**Teeple Architects INC.**

Reviewed (✓)  
 Reviewed as noted (✓)  
 Revise and resubmit ( )  
 Not Reviewed ( )  
 Date: 2015.05.23  
 Reviewed by: [Signature]

SQ ALEXANDRIA PARK  
 BLOCK 11  
 TORONTO, ONTARIO  
 ELEVATORS No. 1 to 3  
**PIT PLAN**

'b'	PIT LADDER SIZE & LOCATION REVISED. GOVERNOR TENSION MOTOR H.P. ALL REVISED IN ELEVATOR DATA.	W.T.	03/08/15
'a'	DIMENSIONS TO COLUMN LINES REVISED. LAYOUT APPROVED AND MADE FINAL.	W.T.	12/27/14
No.	REVISION	BY	DATE
BLDG. NAME	SQ ALEXANDRIA PARK - BLOCK 11		
ADDRESS	TORONTO, ONT.		
	THREE (3) GEARED PASSENGER ELEVATORS		
	<b>SELCO ELEVATORS LTD.</b>		
DRWG. No.	SQ ALEX PARK	REV. 'B'	SHEET 1 of 8

MACHINE ROOM PLAN

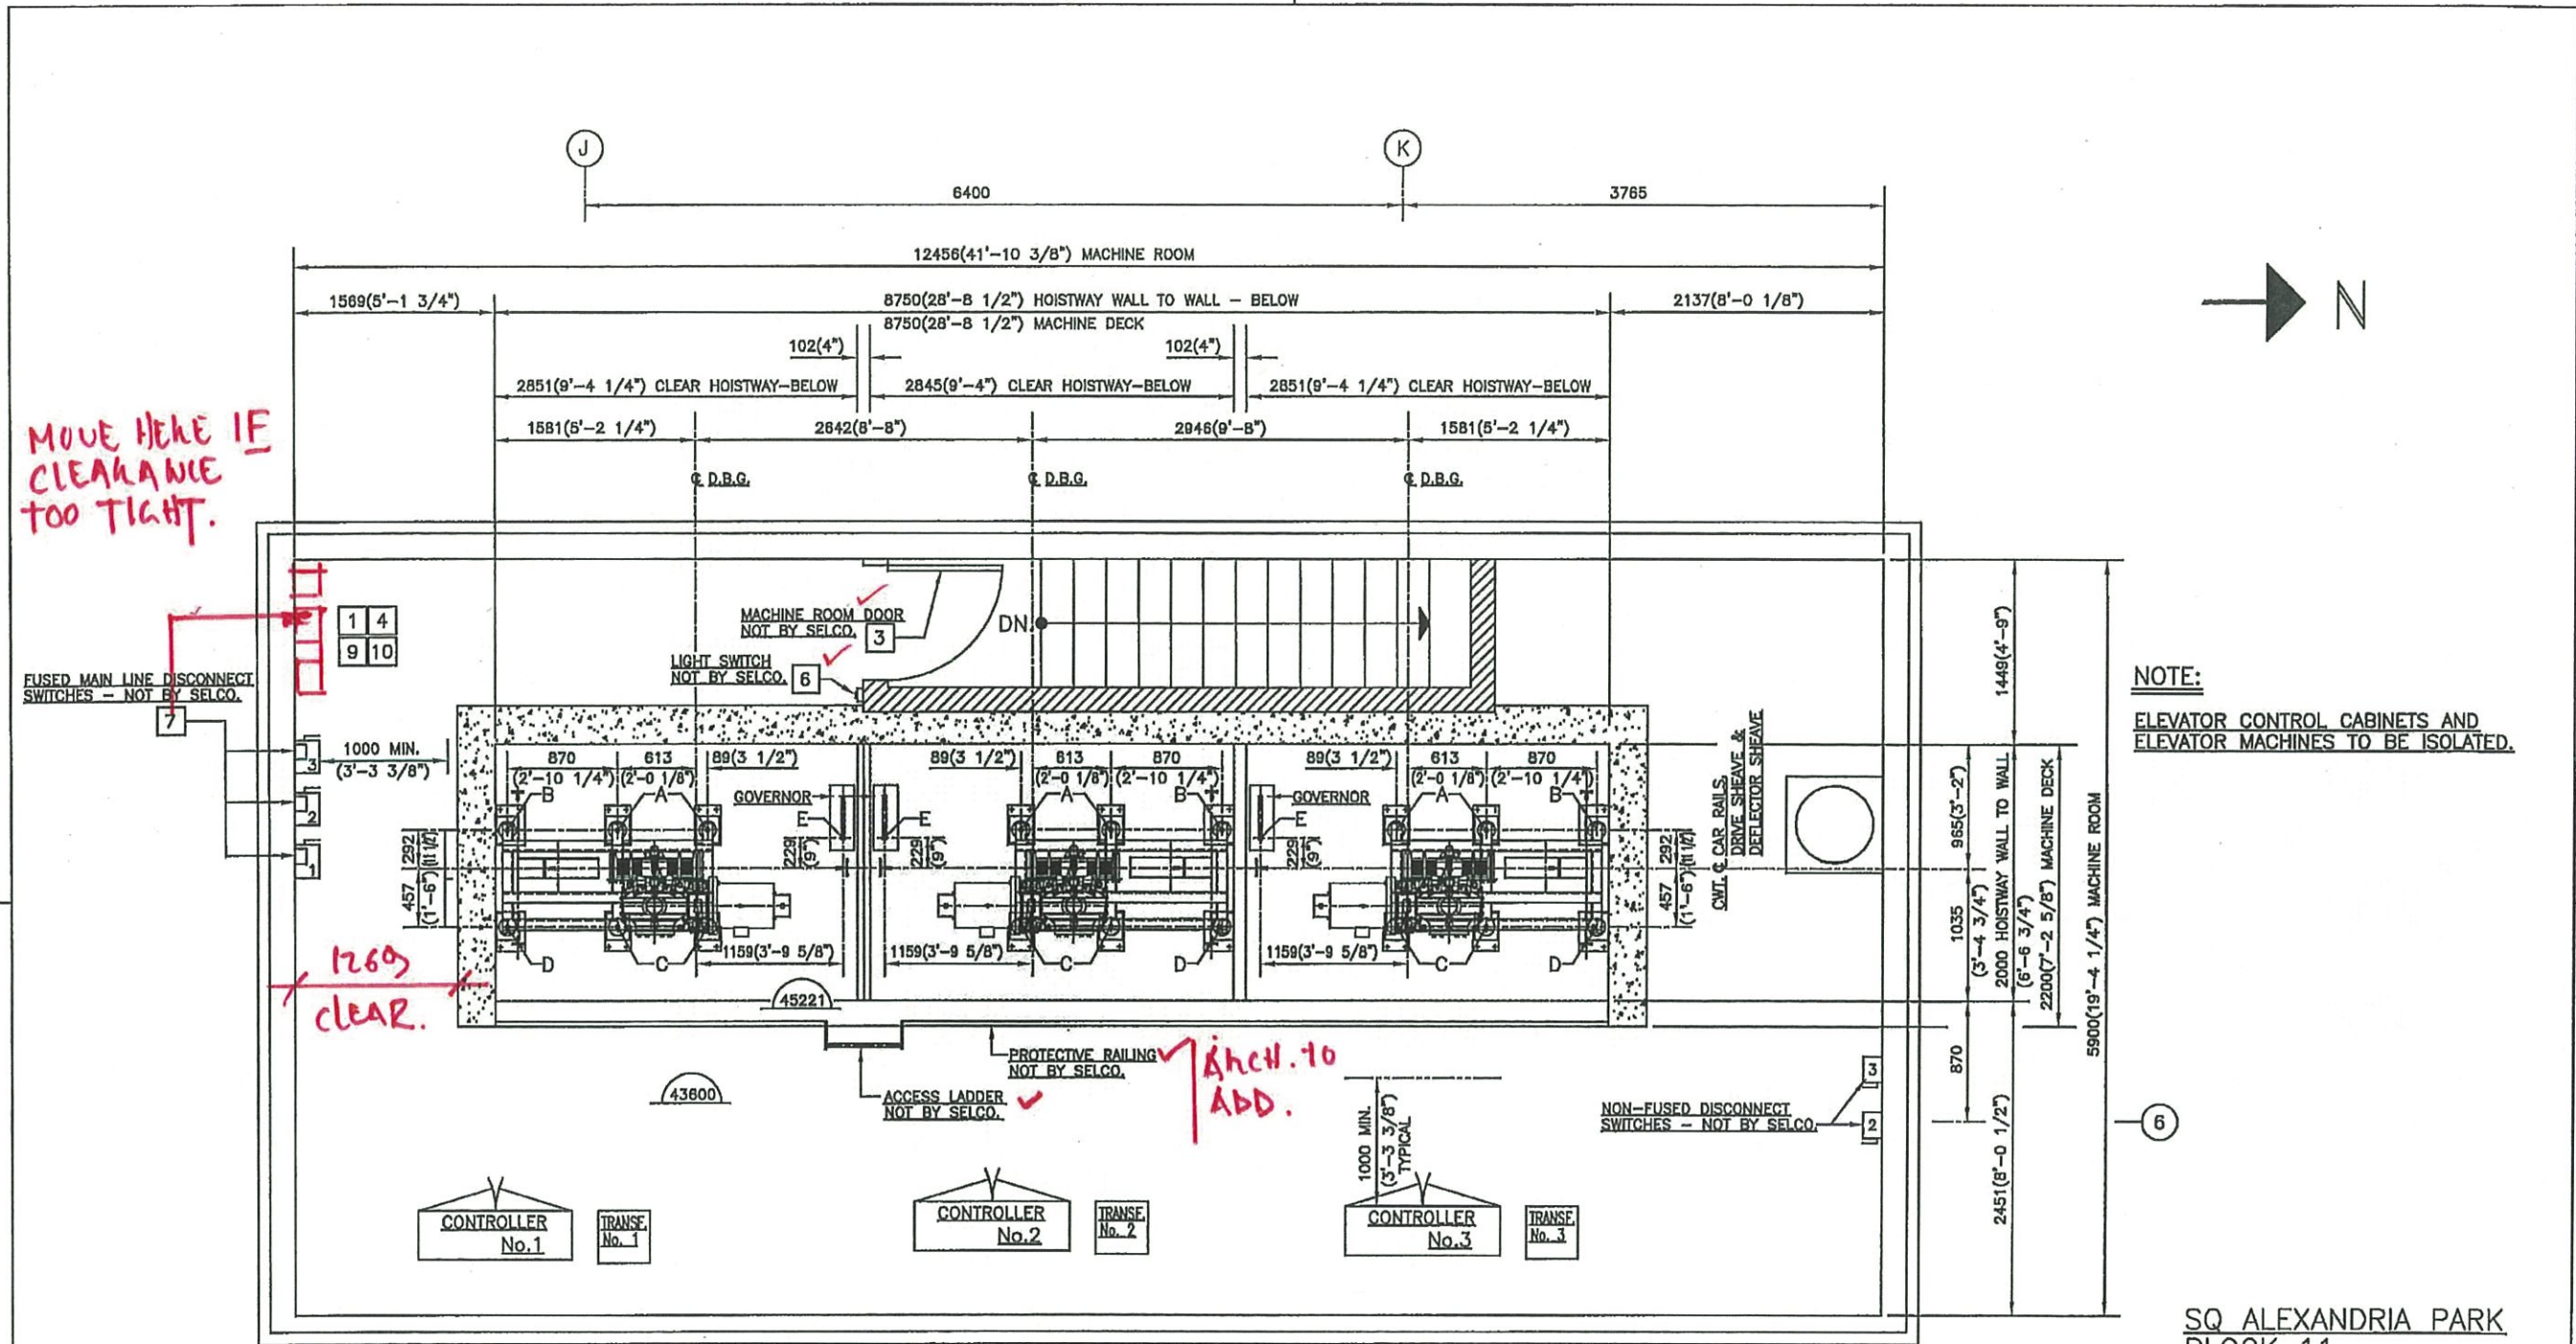
MOVE HERE IF CLEARANCE TOO TIGHT.

STRUCTURAL TO REVIEW.

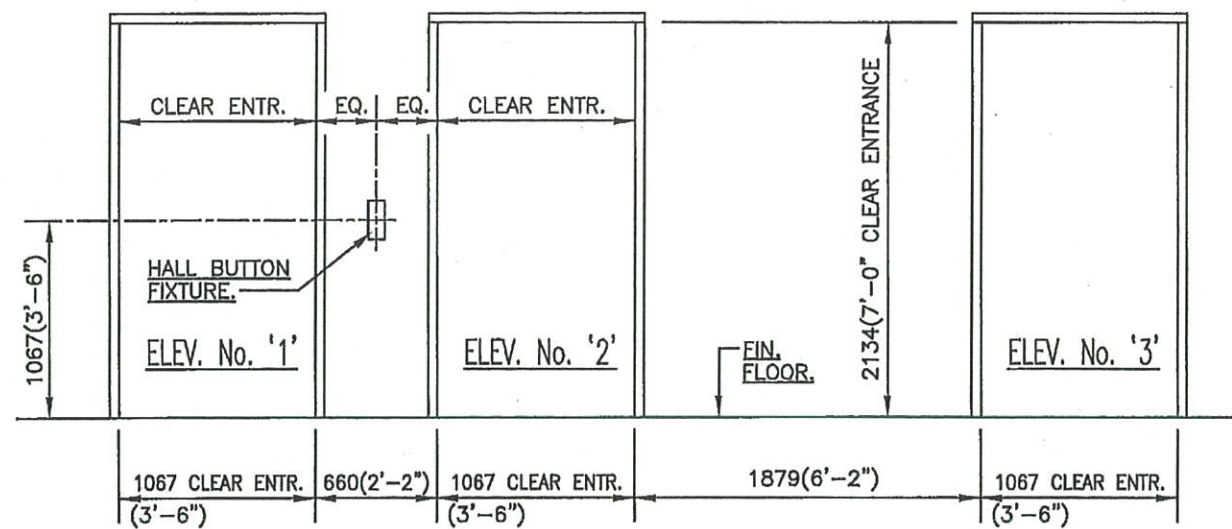
*\* TRIBEL TO CONFIRM IF THERE ARE INDICATORS AT THESE LEVELS. \**

HALL FIXTURE DETAIL at '1st' FLOOR

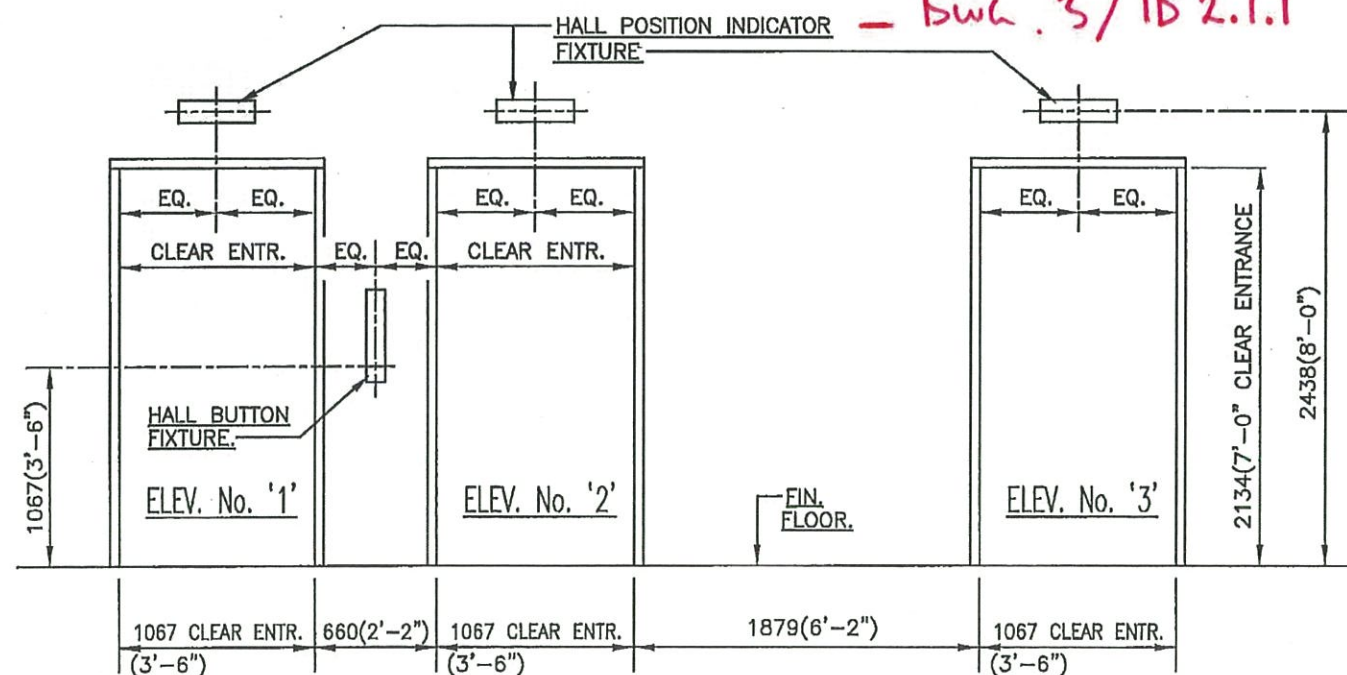
*TO BE COORDINATED WITH INTERIORS - DWG. 3/ID 2.1.1*

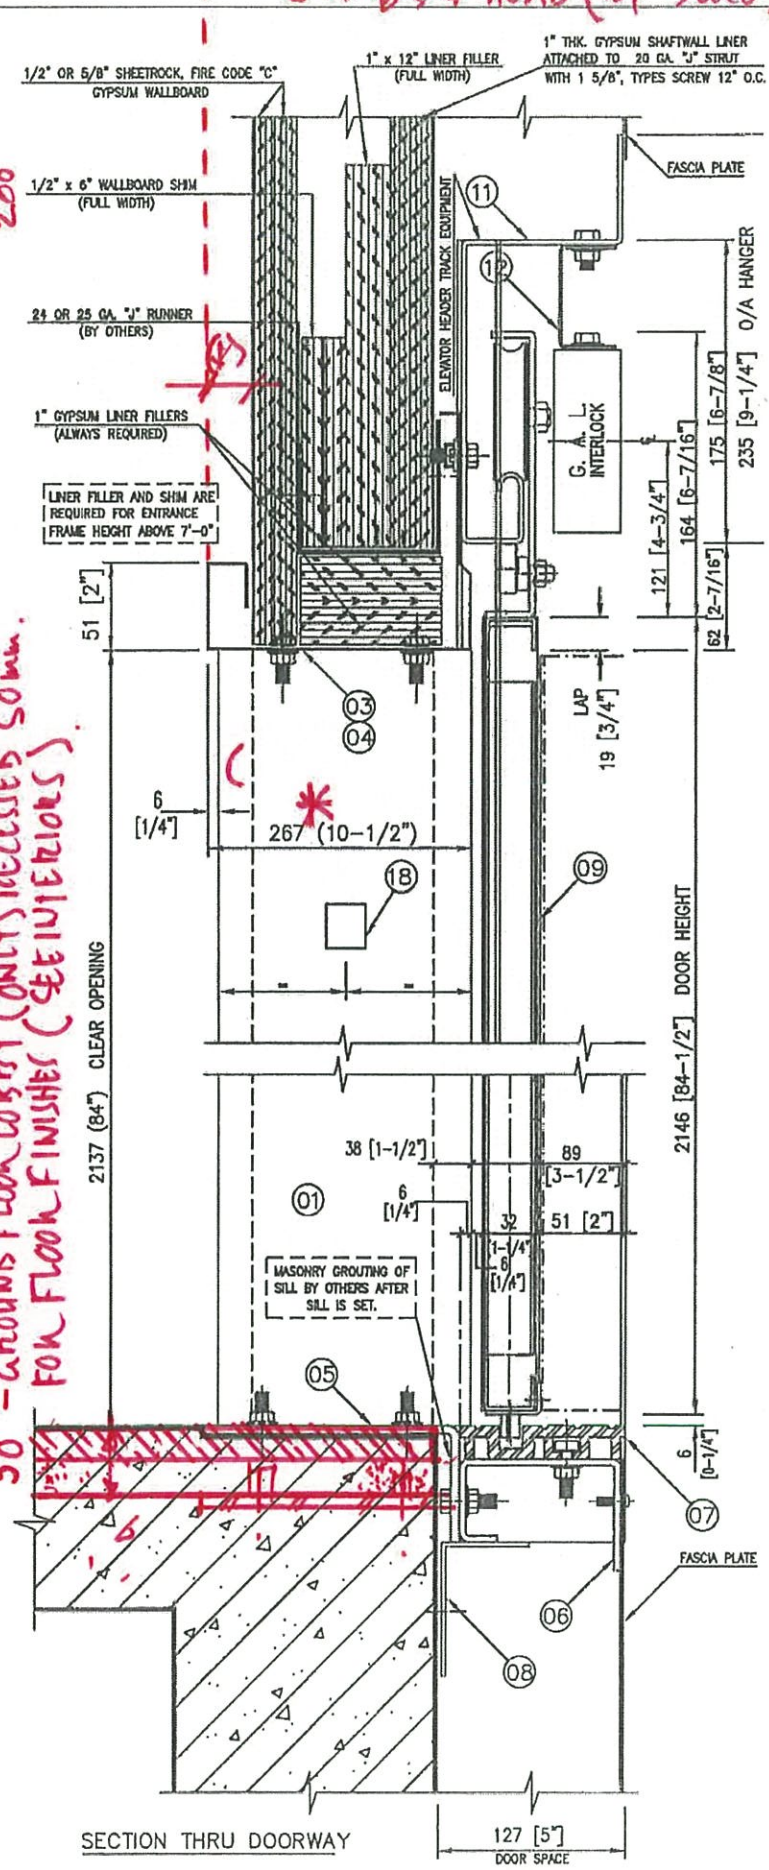
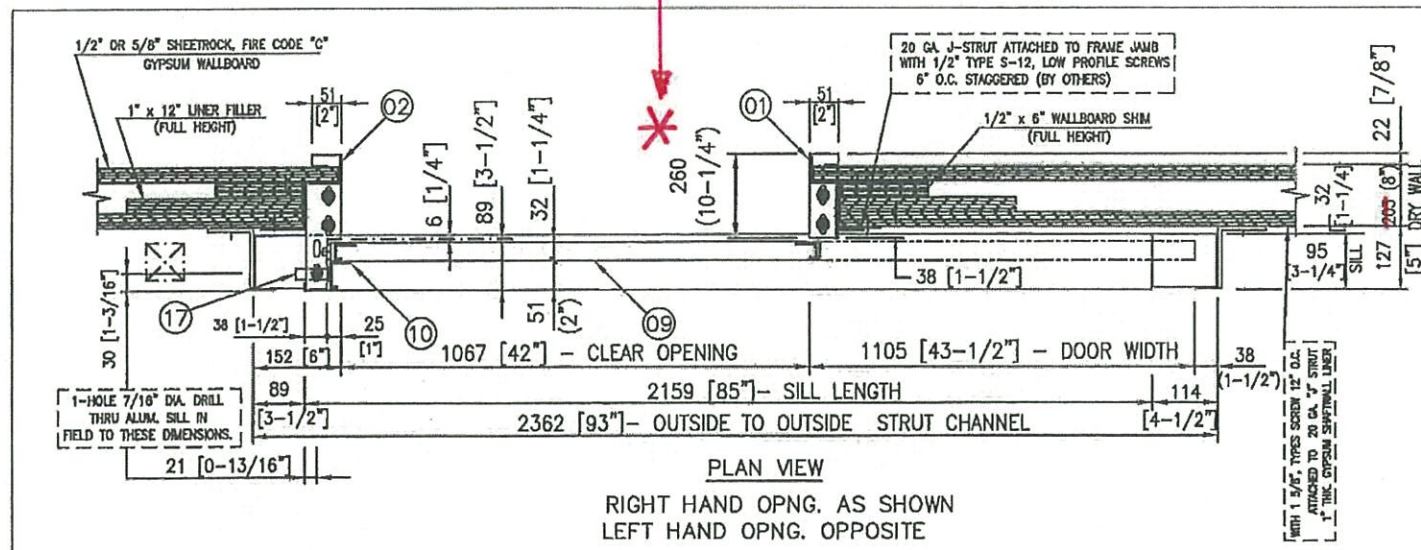
DIMENSION FROM SHAFT WALL TO WALL FINISH (GLASS) LEVEL.  
 \* TO BE PROVIDED BY INTERIORS.  
 JAMBS & HEAD (BY SELCO) DIMENSIONS BY INTERIORS.

- 14 SETS OF RH ENTRANCES REQUIRED FOR ELEVATOR 1  
 (2 C.R.S. CLADDED WITH ST.STL.#4 FIN. 14TH & 1ST FLOORS  
 C.R.S. PRIME POWDER COAT FIN. FOR OTHER FLOORS)
- 14 SETS OF LH ENTRANCES REQUIRED FOR ELEVATOR 2  
 (2 C.R.S. CLADDED WITH ST.STL.#4 FIN. 14TH & 1ST FLOORS  
 C.R.S. PRIME POWDER COAT FIN. FOR OTHER FLOORS)
- 14 SETS OF LH ENTRANCES REQUIRED FOR ELEVATOR 3  
 (2 C.R.S. CLADDED WITH ST.STL.#4 FIN. 14TH & 1ST FLOORS  
 C.R.S. PRIME POWDER COAT FIN. FOR OTHER FLOORS)
- ENTRANCES ARE DRILLED FOR G.A.L. EQUIPMENT.
- EMERGENCY KEY-HOLE REQUIRED FOR ALL ENTRANCES.
- ENTRANCES ARE ULC LABELLED AND FIRE RATED FOR 1 1/2 HOUR.
- PLEASE CONFIRM <sup>200mm</sup> DRY WALL THICKNESS.

WALL ASSEMBLY IS 200mm THICK.  
 (CONC/ CONC.BLOCK (100)/ GYPSUM.  
 RD. WITH GYPSUM SHAFTWALL FINISH  
 AT HOISTWAY SIDE, GYPSUM FINISHING &  
 INTERIOR FINISHES, LOBBY SIDE.)  
 INTERIORS TO CONFIRM HOISTWAY  
 JAMBS DEPTH & CONFIRM MATERIALS.

50 - Grounds Floor Lobby (ONLY RECESSED SOME).  
 FOR FLOOR FINISHES (SEE INTERIORS)
